NEEDHAM PLANNING BOARD
Thursday July 7, 2022
7:00 p.m.

7:15 p.m. Major Project Site Plan Special Permit No. 2022-02: 557 Highland, LLC, an affiliate of The Bulfinch Companies, Inc., 116 Huntington Avenue, Suite 600, Boston, MA, Petitioner. (Property located at 557 Highland Avenue, Needham, Massachusetts). Regarding proposal to redevelop the Property with approximately 496,694 square feet of office, laboratory and research and development uses (see legal notice and application for more details). *Please note: this hearing has been continued from the June 7, 2022 meeting of the Planning Board.*

Figure 16 provides an illustration of the proposed improvements along Gould Street and at this intersection. A summary of the traffic operations with the proposed mitigation in place is provided in the following section.

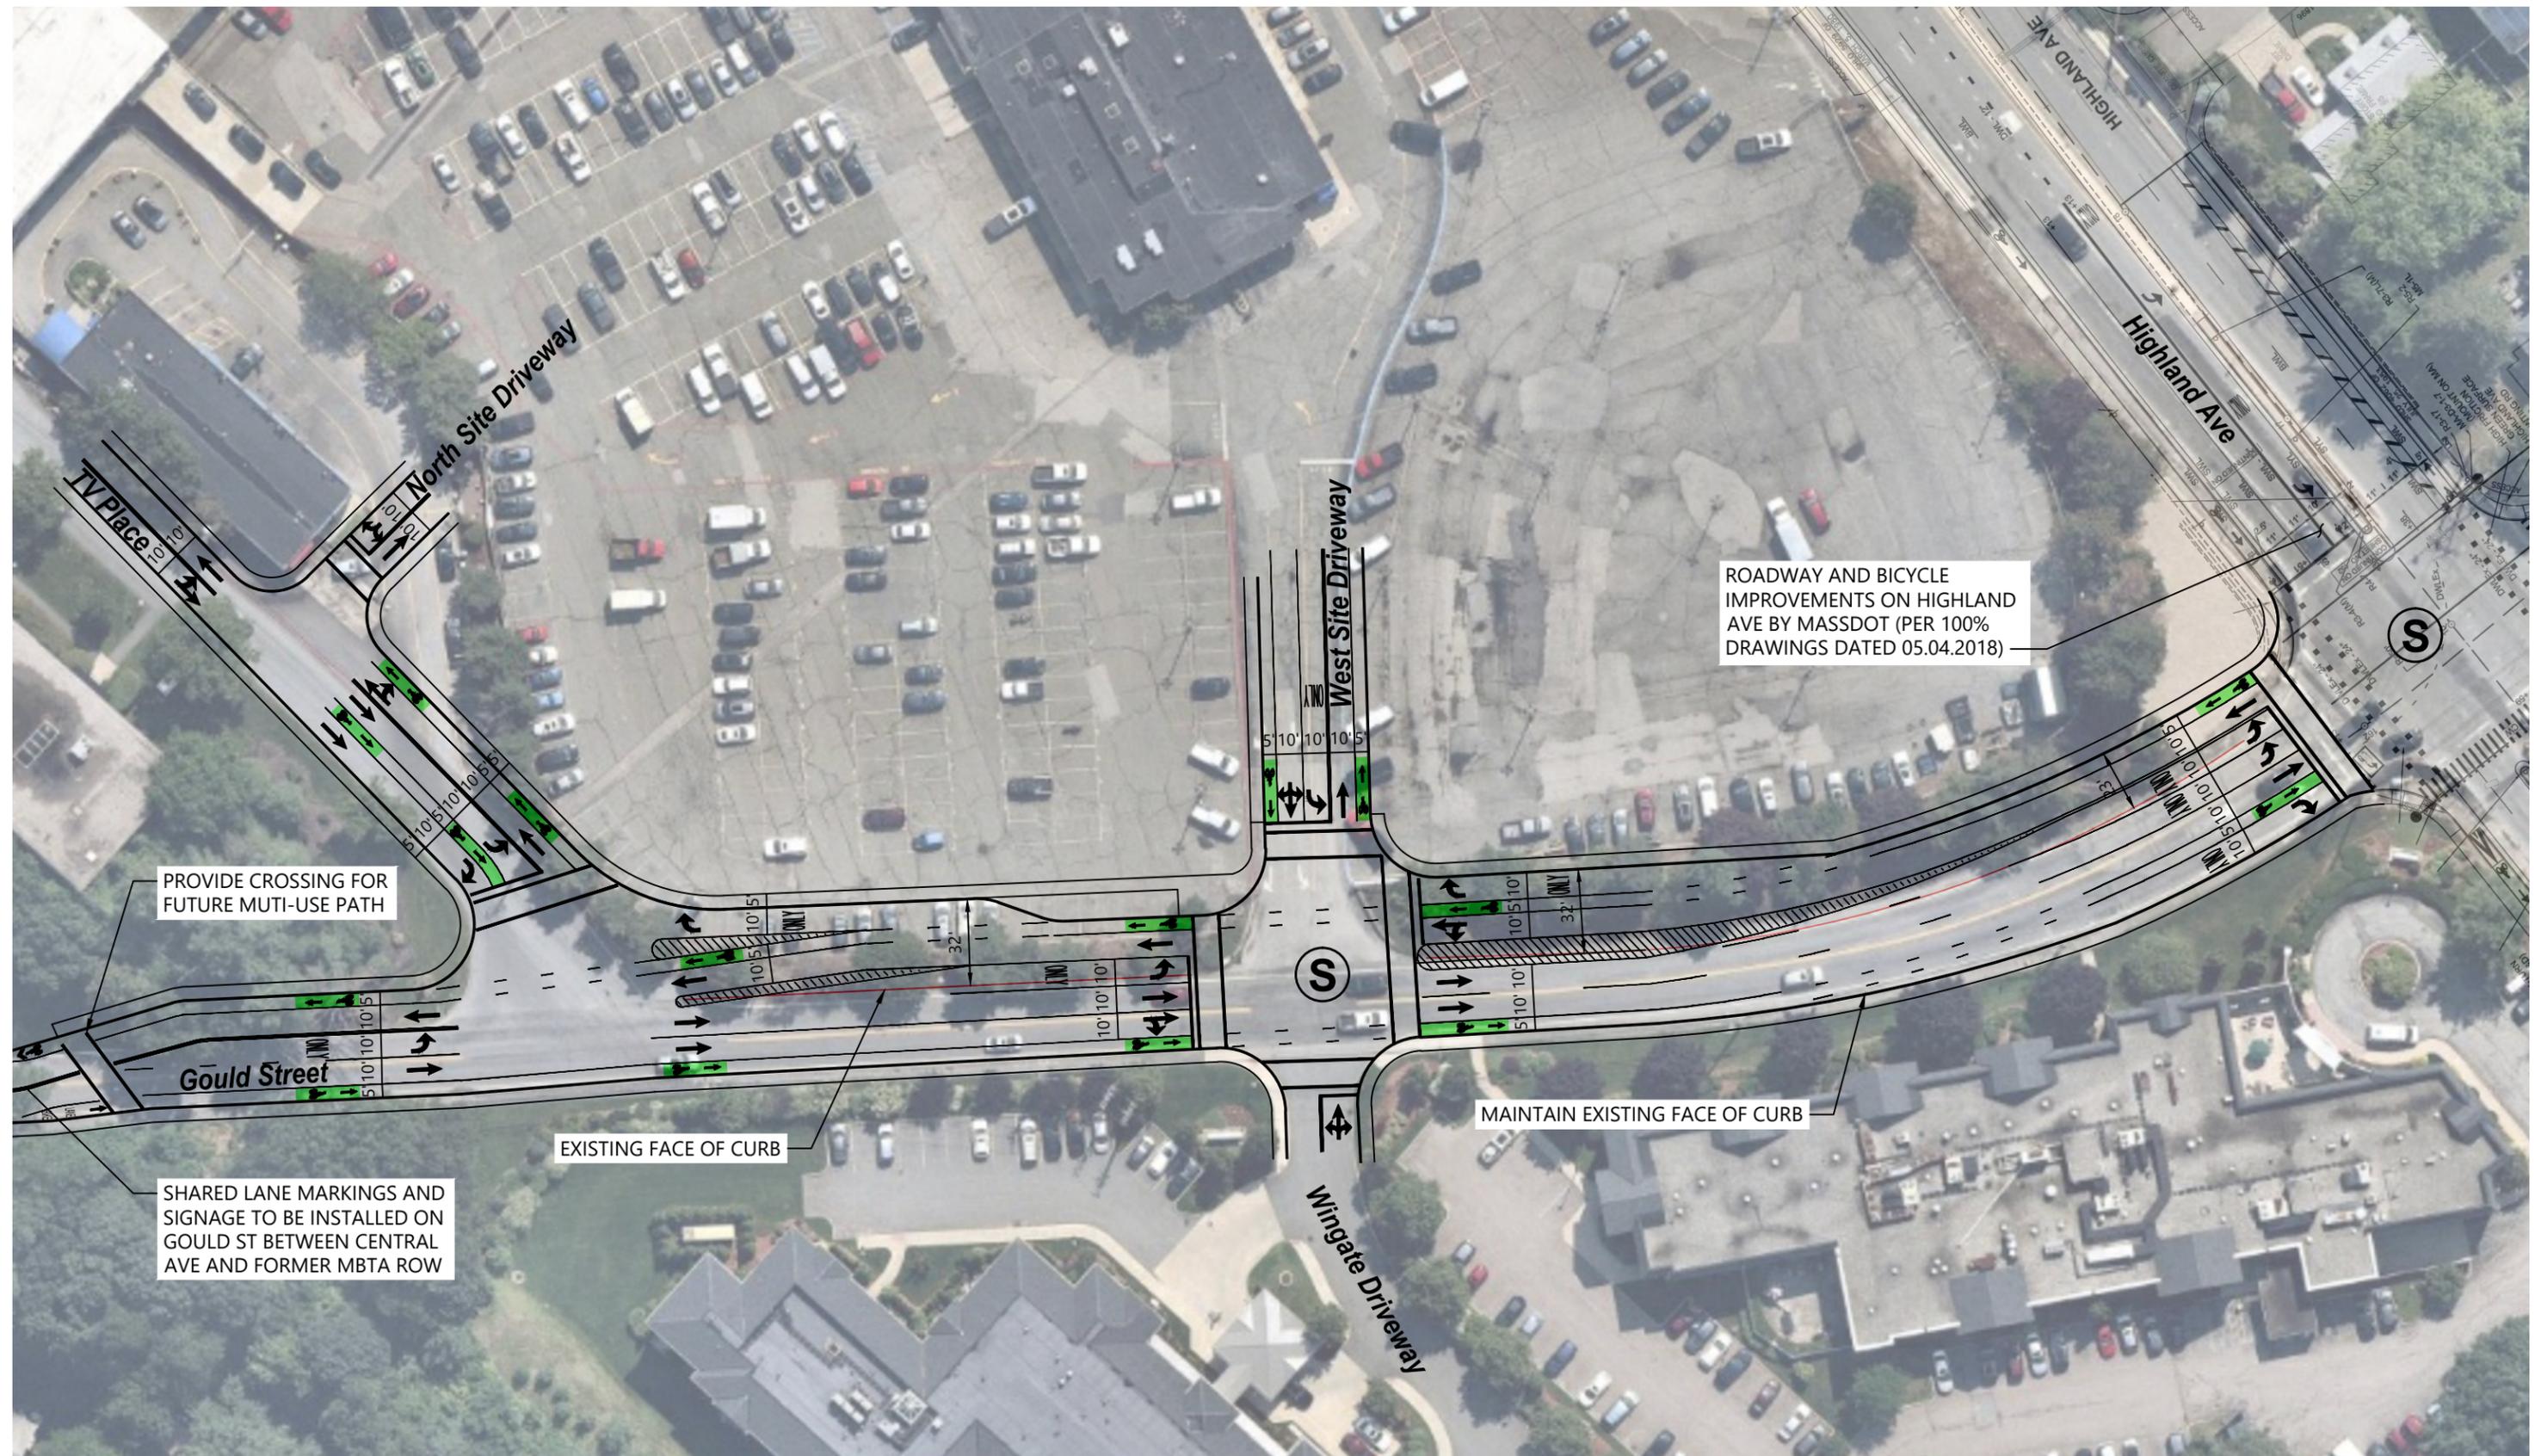
18. The TIAS describes geometric improvements that are proposed at the intersection of Highland Avenue / Gould Street / Hunting Road as mitigation for the project, which are shown graphically in Figure 16. The widening of the roadway that will be required to accommodate the additional lanes at this location will also likely require reconstruction of the traffic signal at this intersection to accommodate new signal indications and mast arms, as well as vehicle detection and pedestrian signal equipment. No mention of the signal upgrades was provided in the TIAS and no signal improvements are shown in Figure 16.

19. Figure 16 of the TIAS provides a graphic depiction of the roadway geometry proposed at the intersection of Highland Avenue / Gould Street / Hunting Road and along Gould Street fronting the site. The Figure does not include the Highland Avenue eastbound or Hunting Road northbound approaches to the intersection, so it is difficult to identify what, if any, improvements are proposed on those approaches. However, Figure 1.4 of the ENF also provides a similar graphic that includes all approaches to the intersection. While the geometry on the majority of the approaches appears consistent with the conceptual improvement sketches prepared as part of the former rezoning effort, the Hunting Road northbound approach to Highland Avenue and the receiving approach on Gould Street are inconsistent with the rezoning plans. The analysis and plans prepared as part of the rezone indicated that two through lanes would be required on Hunting Road with two receiving lanes on Gould Street to accommodate the traffic generated by the project. The capacity and queue analysis summarized in Table 15 of the TIAS indicates that even with the mitigation measures proposed by the Applicant, the Hunting Road northbound movement will operate over capacity at level-of-service (LOS) F during the weekday AM and PM peak hours under 2029 Build with Mitigation conditions. The Highland Avenue eastbound left-turn movement will also operate at LOS F during the weekday AM peak hour. Therefore, the Applicant should consider the feasibility of providing an additional northbound lane on Hunting Road to improve the capacity and operations of this intersection.
